Title: Calidus mast bracket replacement		
AG-SB-2022-01-C-EN	Effective Date: 05 APR 2022	Compliance Category:
Applicability		A - MANDATORY B - RECOMMENDED C - OPTIONAL
Aircraft type & model: Calidus	Affected Serial number(s): All; aftermarket repair	
The maintenance manual to be referenced is this stated or subsequent issue.		As per AutoGyro website
This form is the response from AutoGyro GmbH either against a problem found in the product in service requiring a containment or rectification action, or as service information for aircraft modification incorporation. For help, contact airworthiness@auto-gyro.com .

Reason and overview of the Service Bulletin (cause of problem if known)

Solidworks view of the improved attachment between the mast and body.

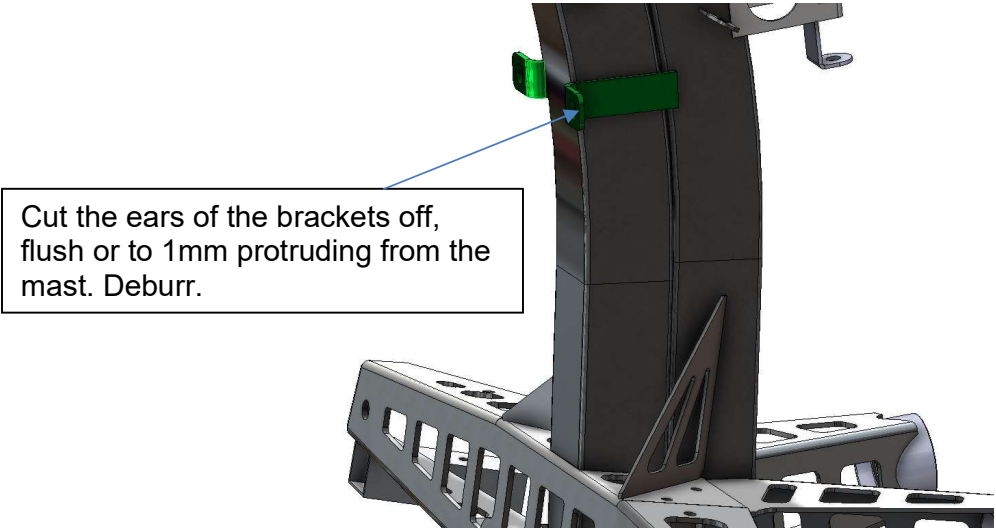
In response to occasional reports of both a crack in the upper mast to body mounting bracket or forward mast in the same area, AutoGyro has developed a repair method to replace the upper mast to body mounting bracket with a separate bracket. This allows mast flexure whilst still providing a secure fixing to the front body. This also allows easy repair without welding, or in-service upgrade.

Pic. 1

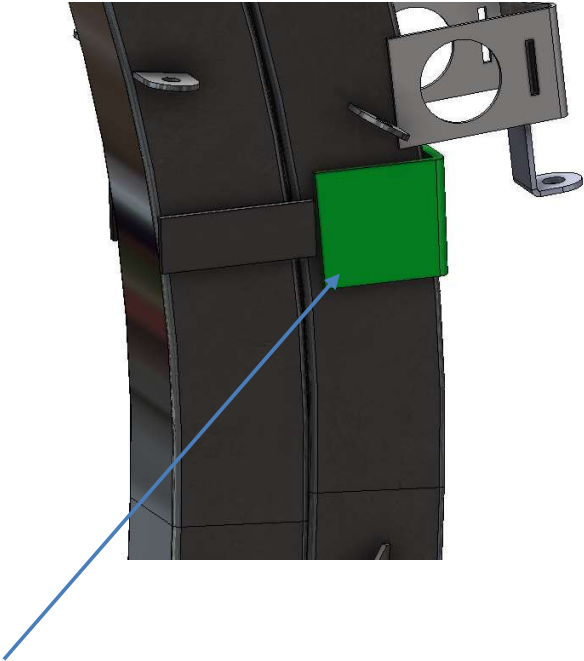
Affix the rubber pad to the mast as shown.

9. Remove the backing strip from the self adhesive rubber and adhere to the mast. Firmly press onto the mast to ensure good adhesion.
10. Fit the bracket around the mast as shown and attach with the new fastenings. Tighten to 25Nm.

Pic. 2

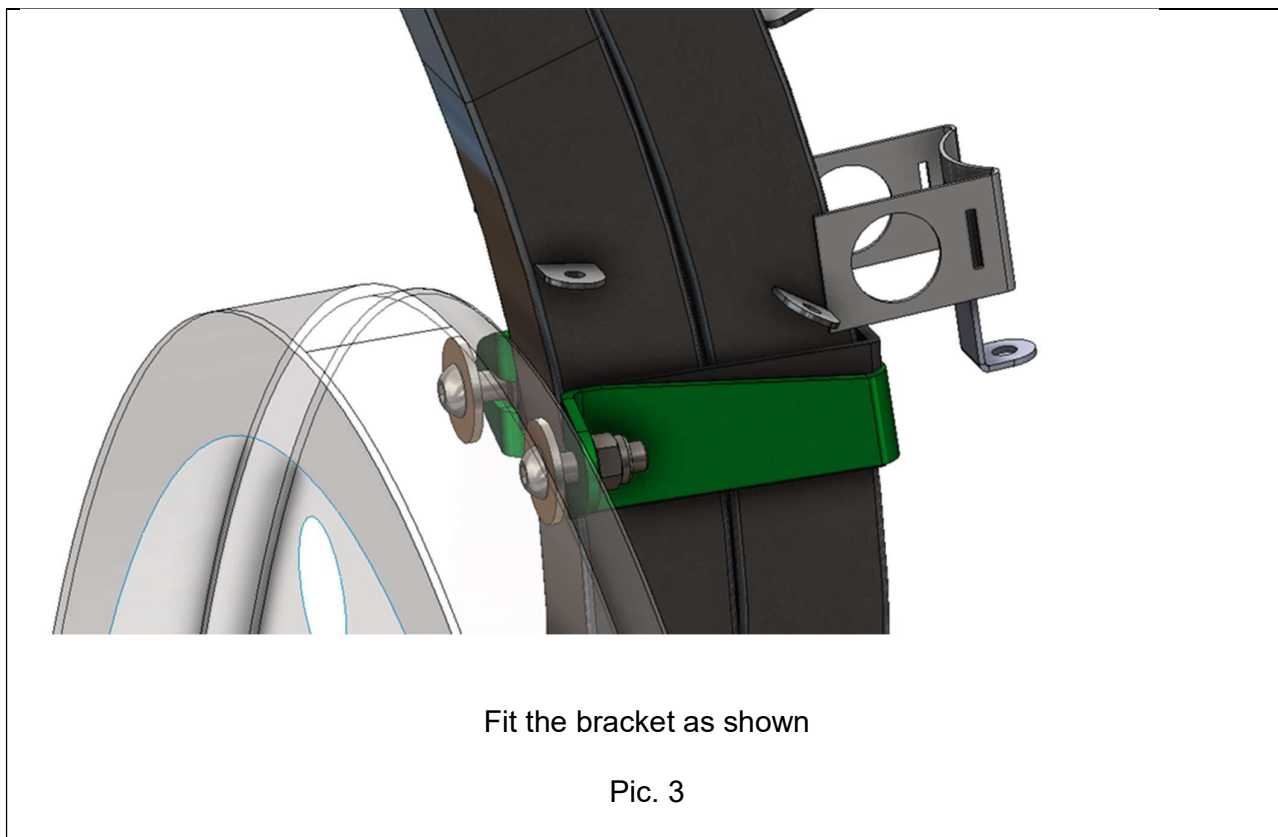
11. This should result in light compression of the rubber pad. If compression is excessive, fit a suitable U10 washer between the bracket face and the cabin, both mast sides.
